# Protest by TC

## 1. Event Name: 41 Copa del Rey MAPFRE

### INFORME DE MEDICIÓN 31.07.2023

#### Apunte de seguridad embarcación S/Y PLAN B GER-6533

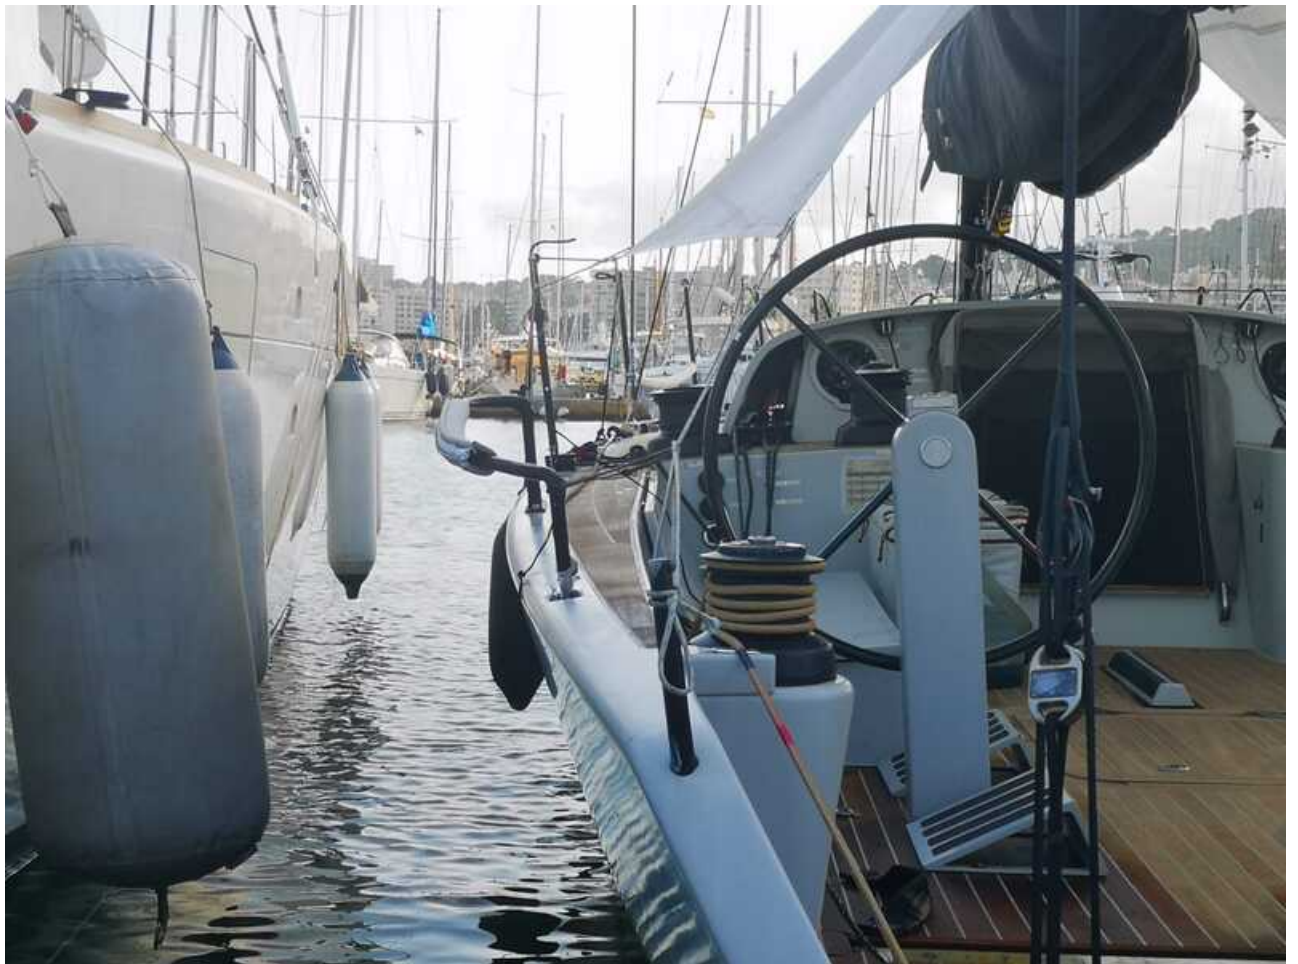
Tras inspección de medición en el agua se observa que los guardamancebos y candeleros de la embarcación incumplen la normativa vigente de las Offshore Special Regulations (OSR). Así como dicta la regla abajo descrita (Anexo I del presente informe). La embarcación no cumple con las alturas mínimas de los candeleros y guardamancebos instalados en la cubierta de trabajo.

- b) **Minimum heights of lifelines and pulpit rails above the working deck and vertical openings:**
  - i. **upper: 600 mm (24")**
  - ii. **intermediate: 230 mm (9")**
